PLAN AND PROFILE OF PROPOSED STATE HIGHWAY

PRINCE WILLIAM PARKWAY INTERCHANGE AT REALIGNED BALLS FORD ROAD

VDOT Proj.No.6234-076-266

Notice of Design Change (NDC) #02
JUNE 2021

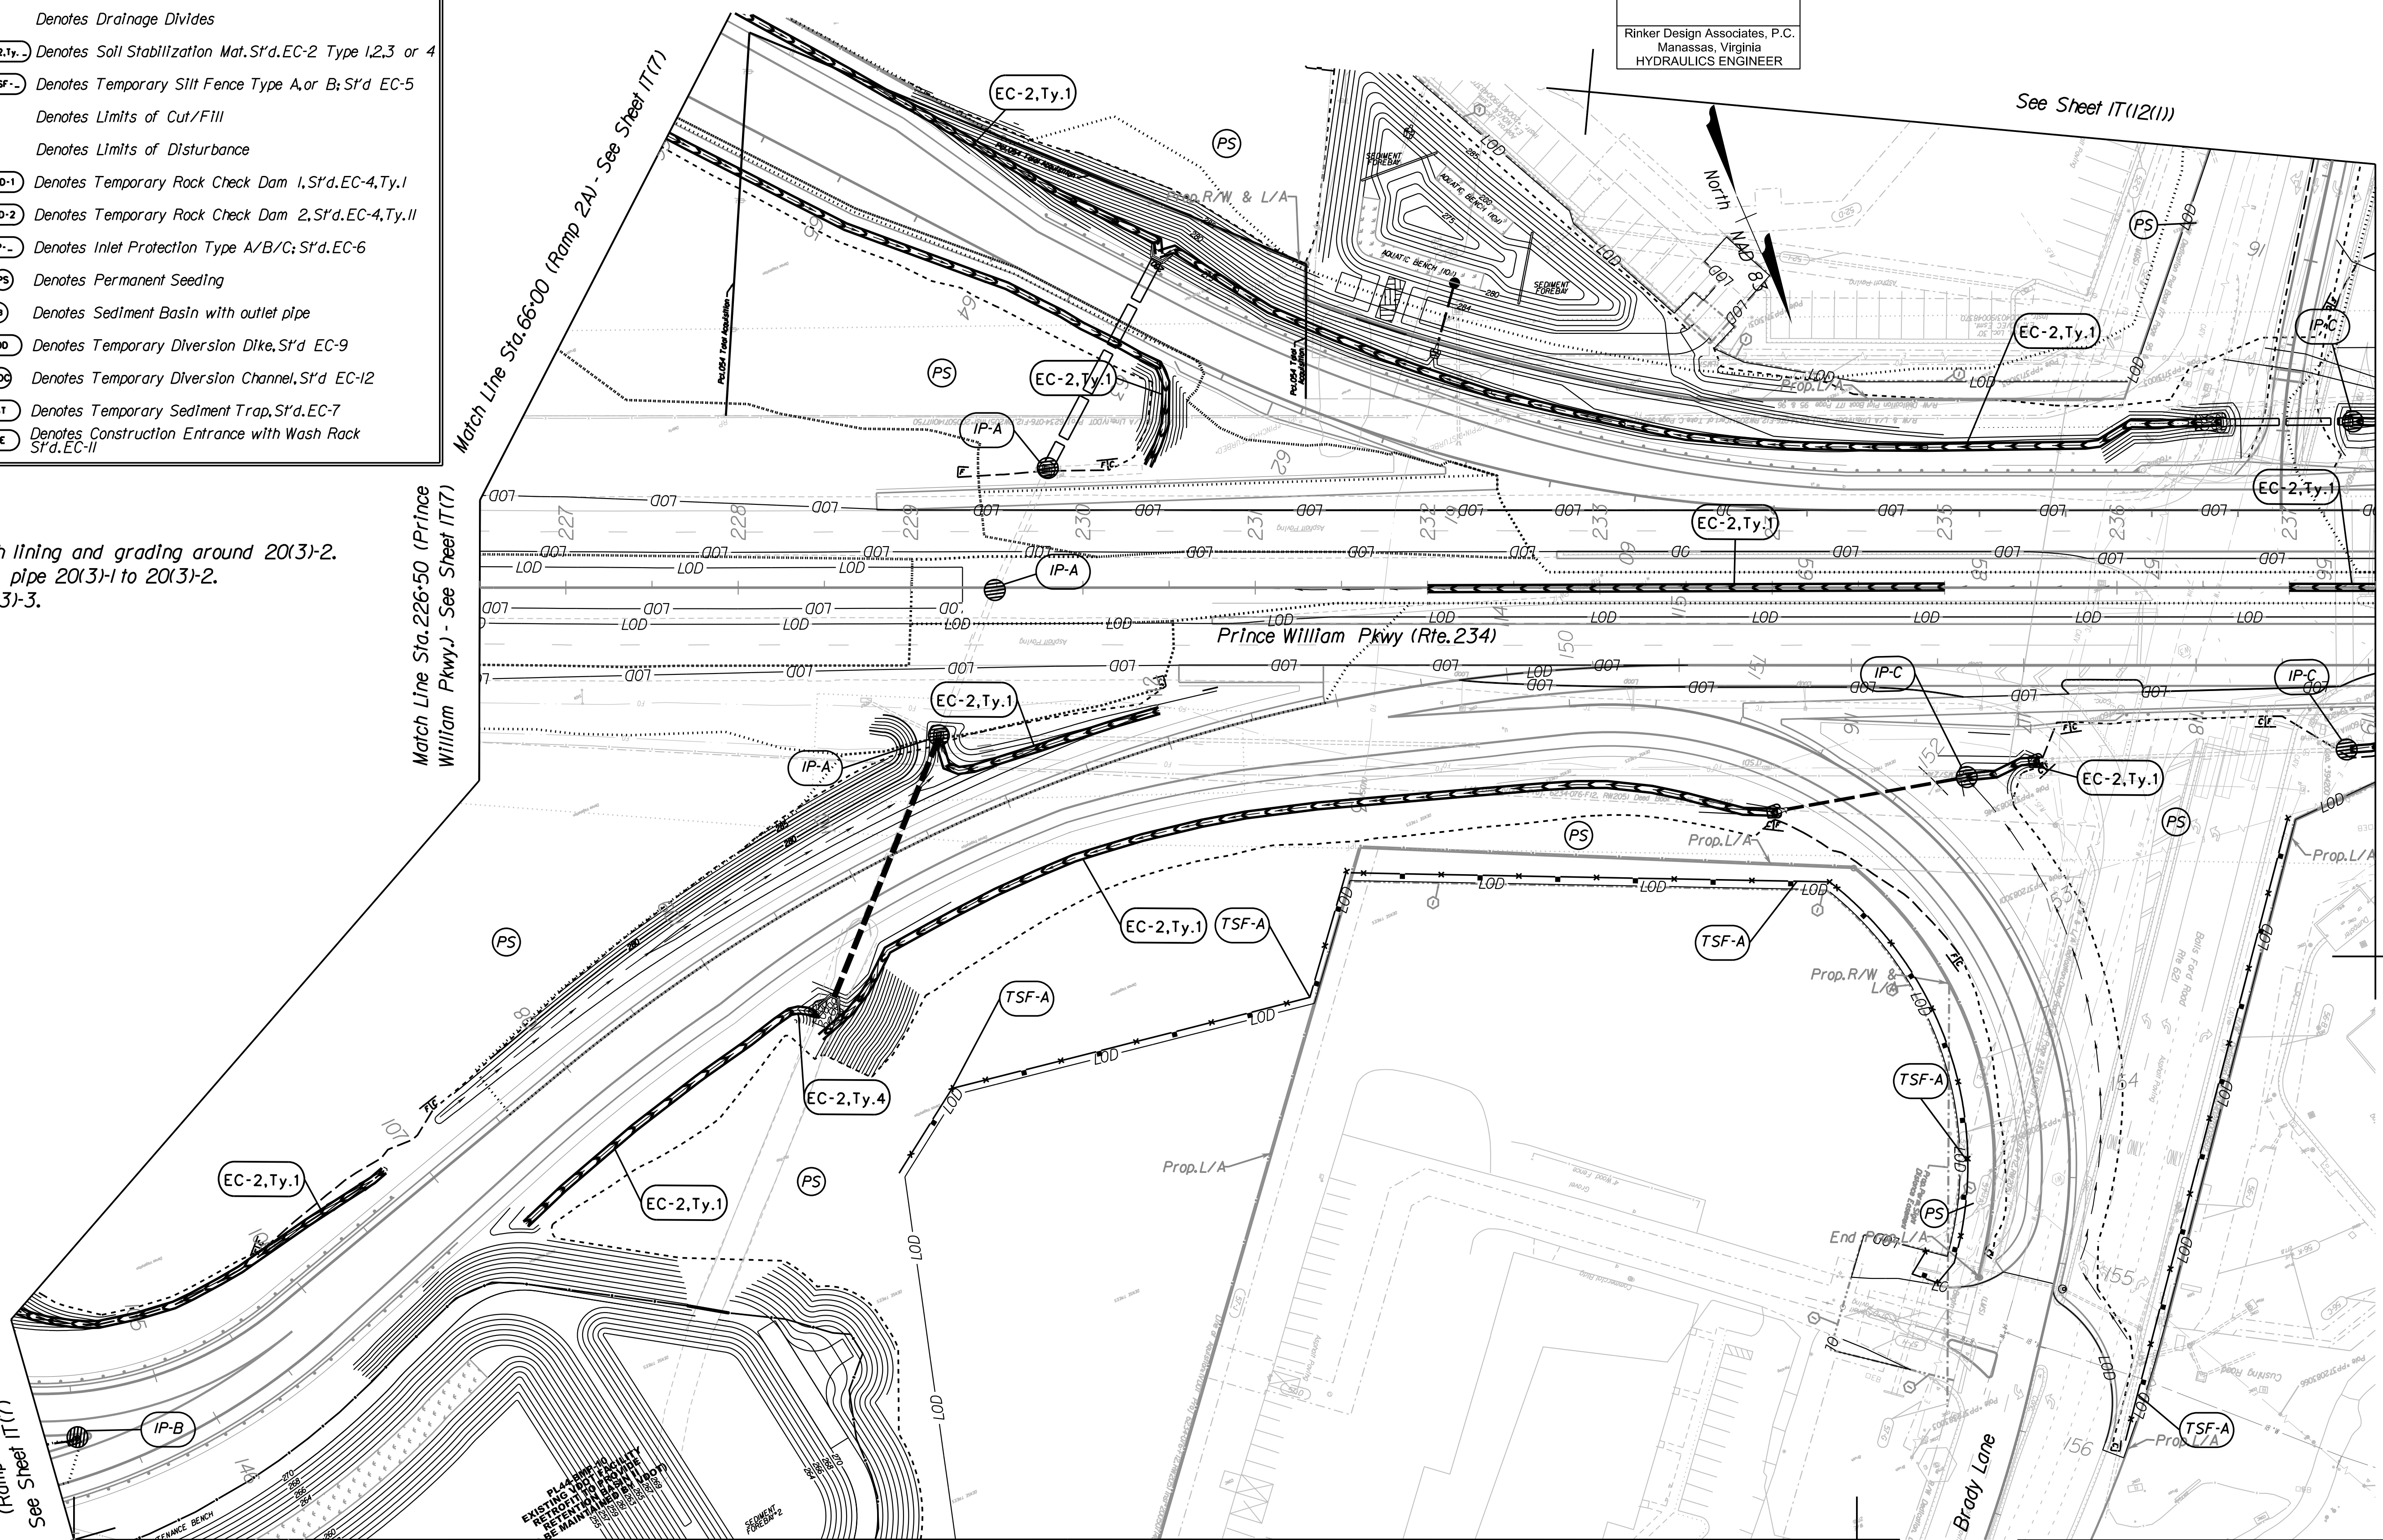
02 Revised ditch lining and grading around 20(3)-2. Added storm pipe 20(3)-1 to 20(3)-2. Removed 20(3)-3.

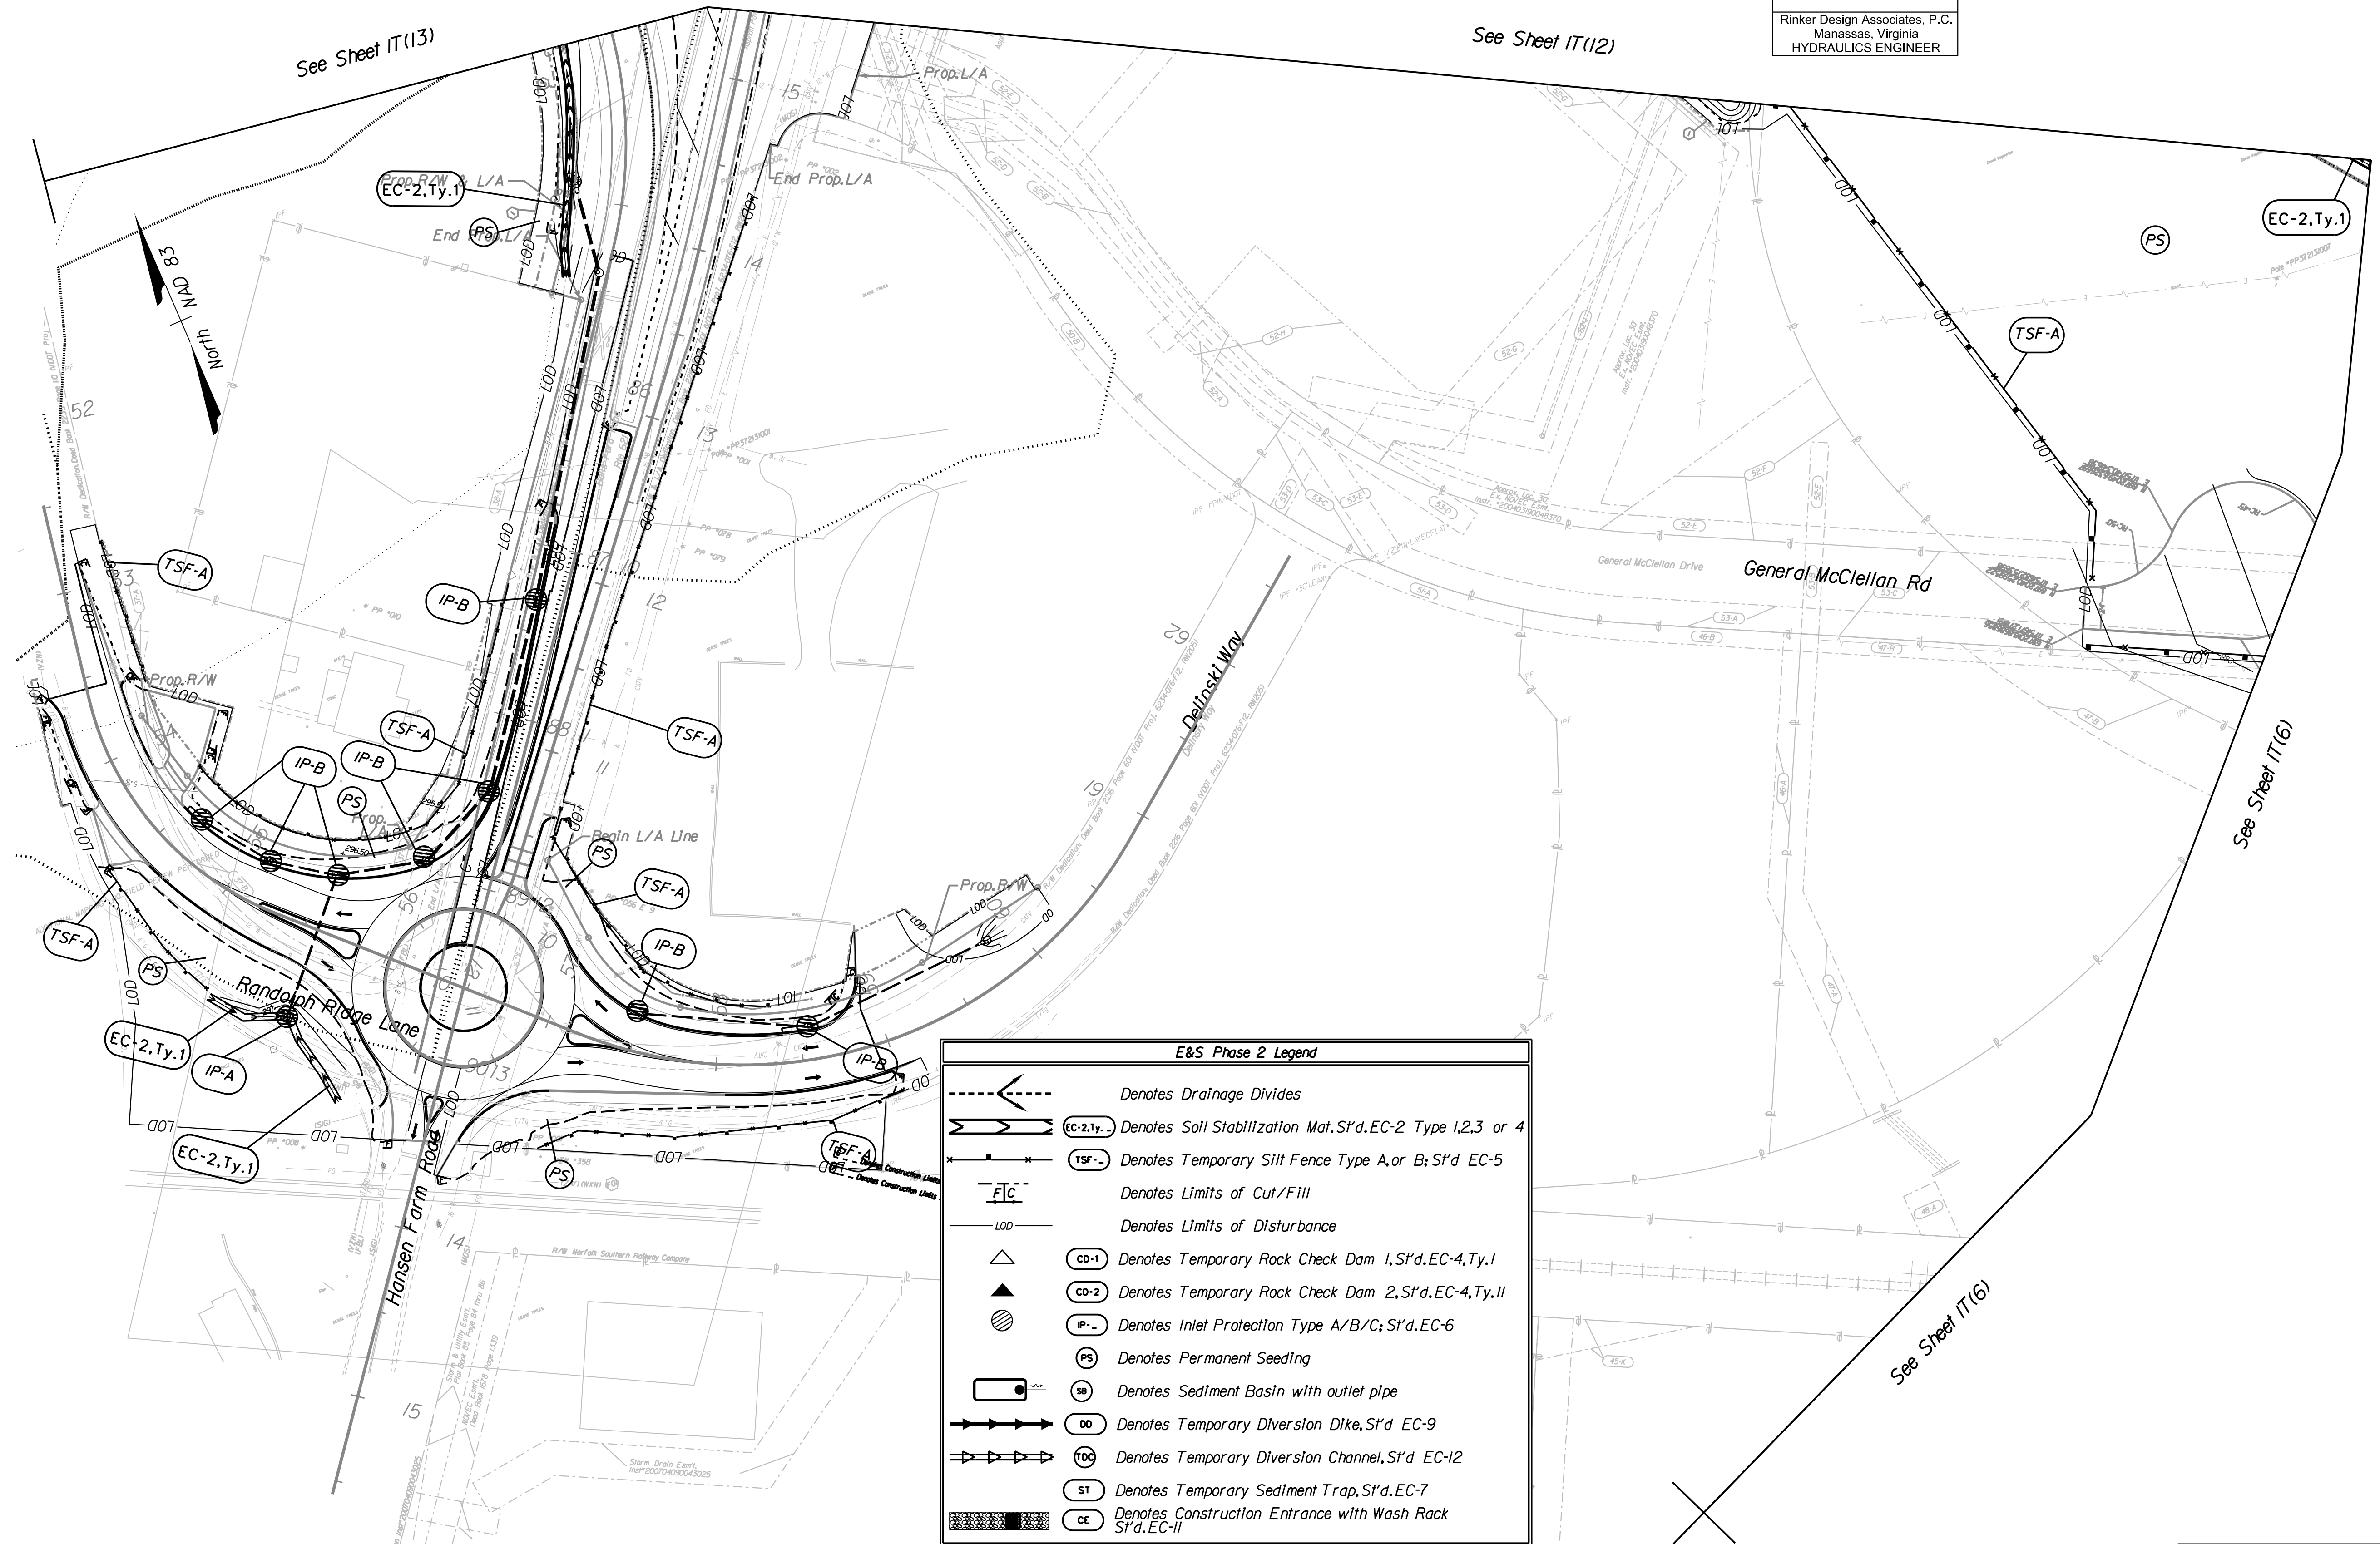
02 Revised to include roundabout ESC measures.

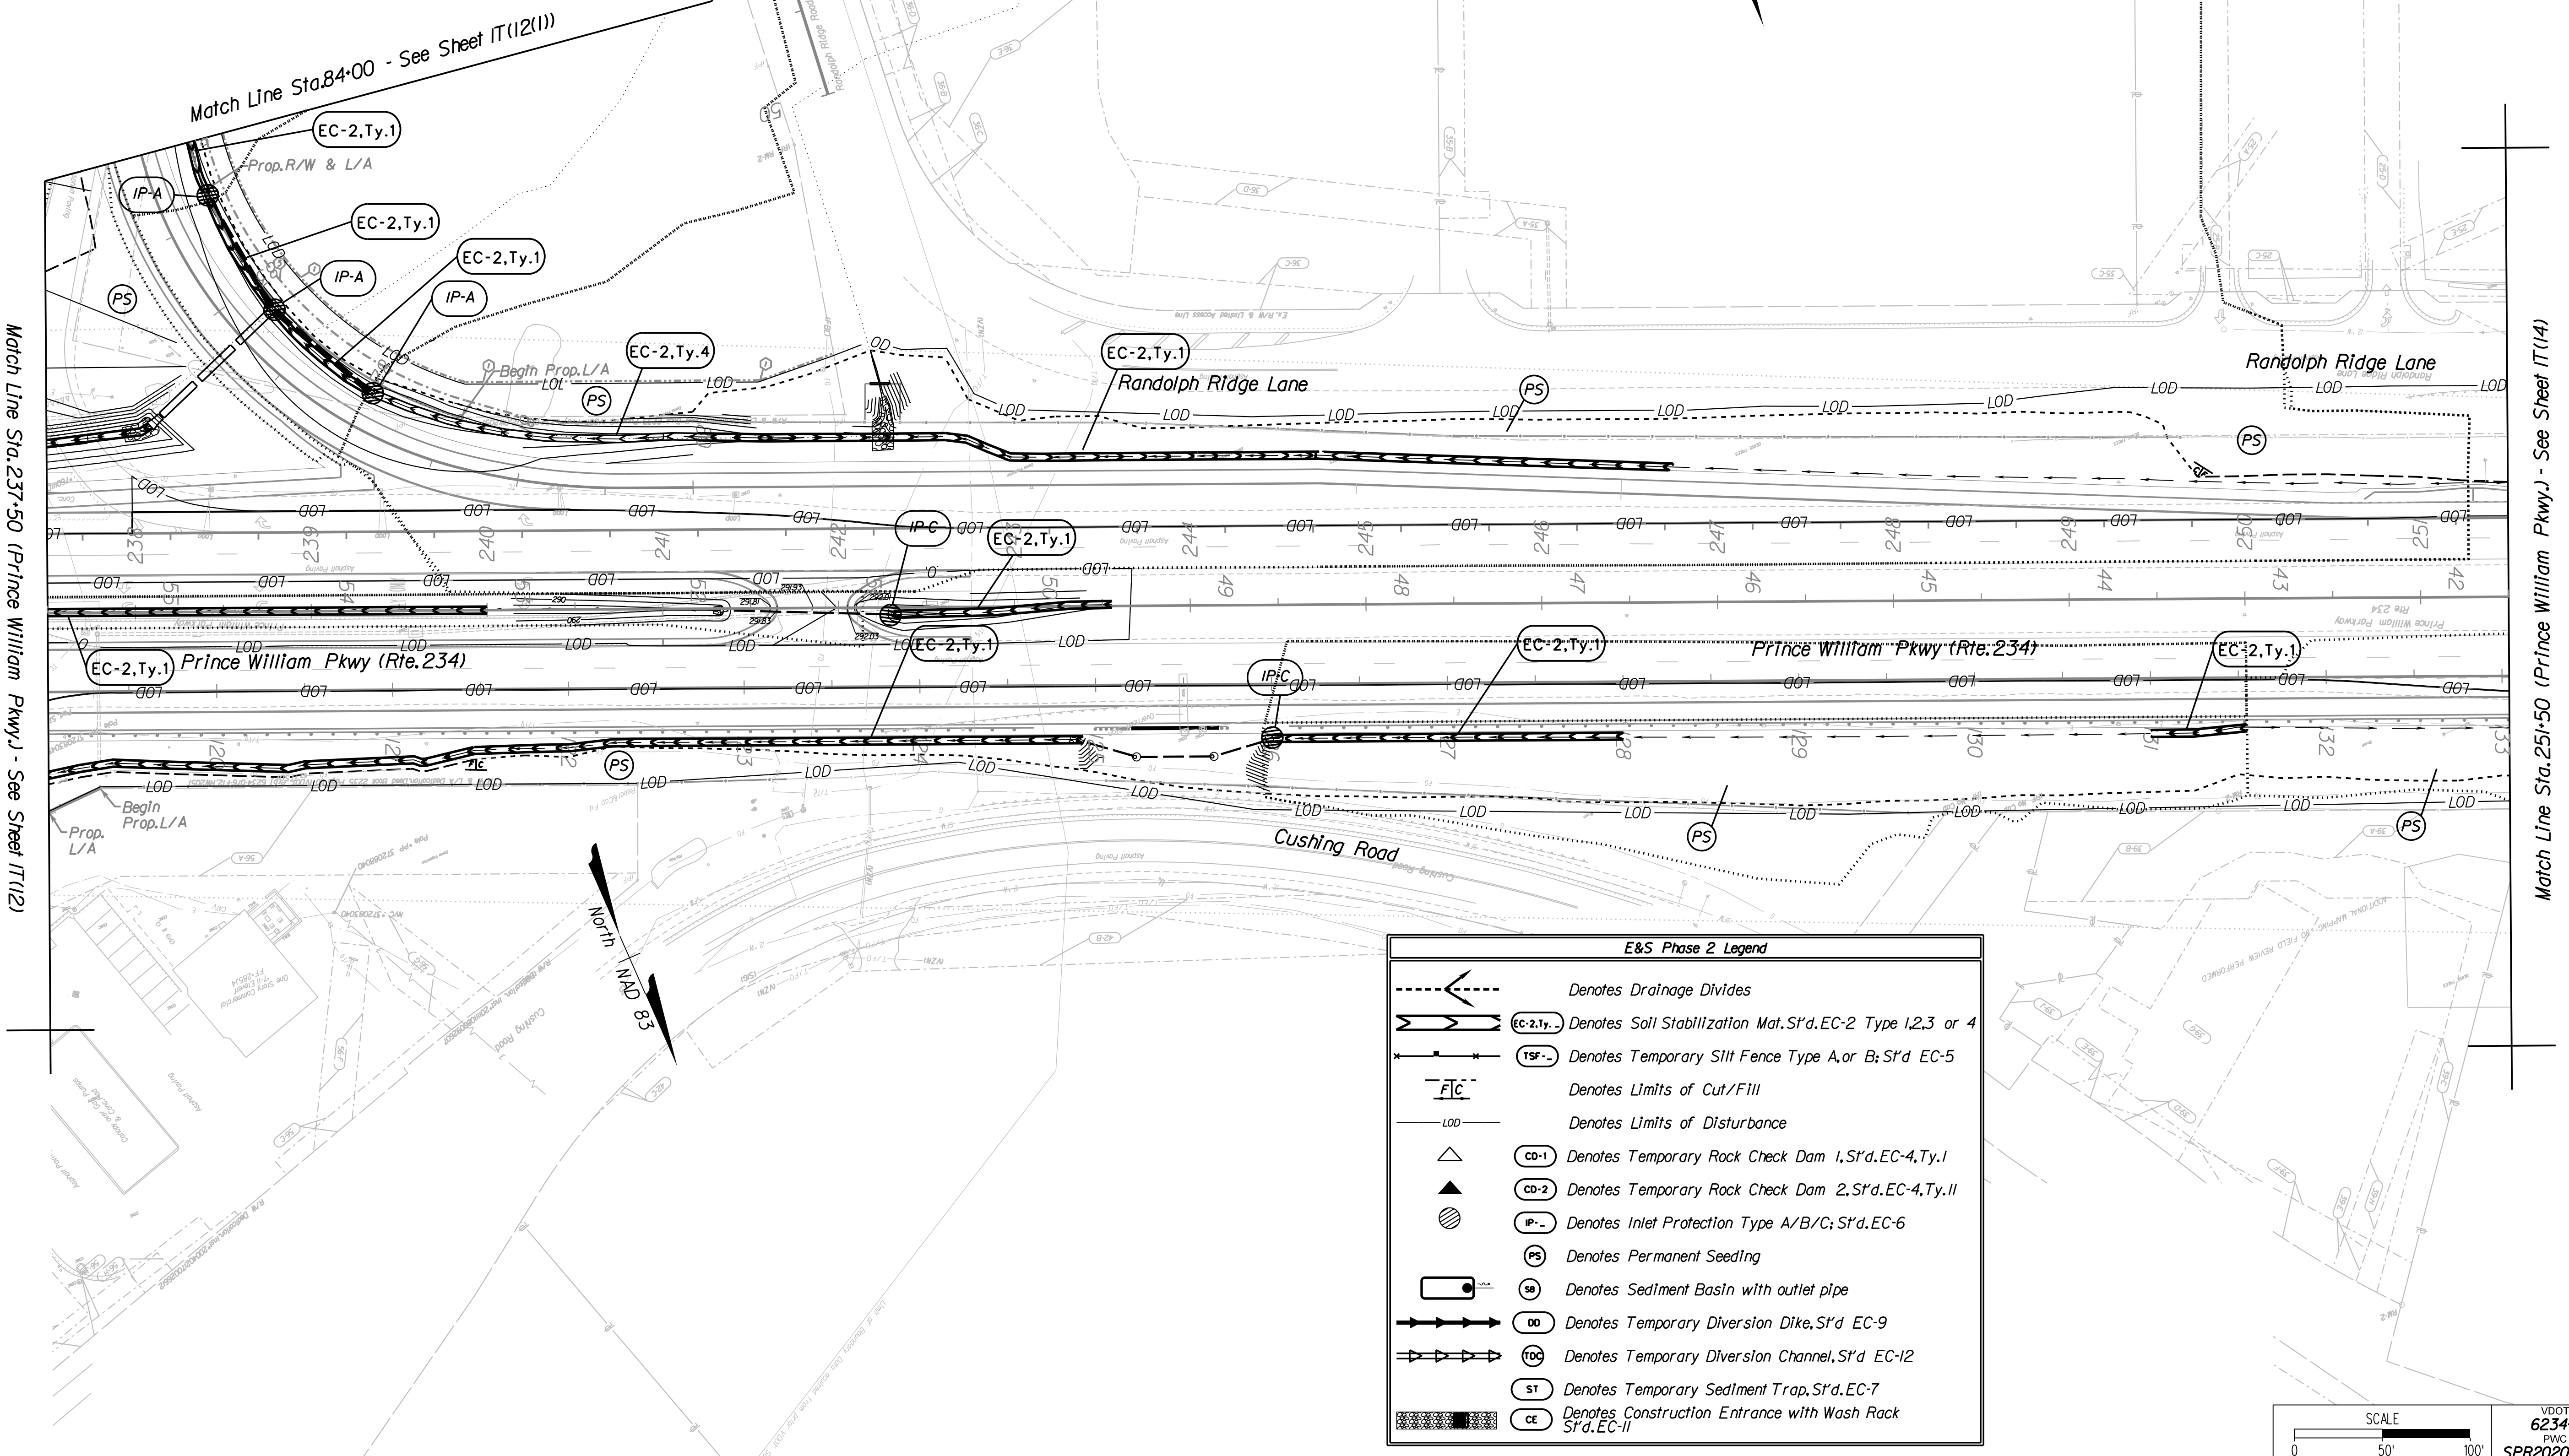
02 Revised ditch lining, Added ditch and Culvert 3(13)-16.
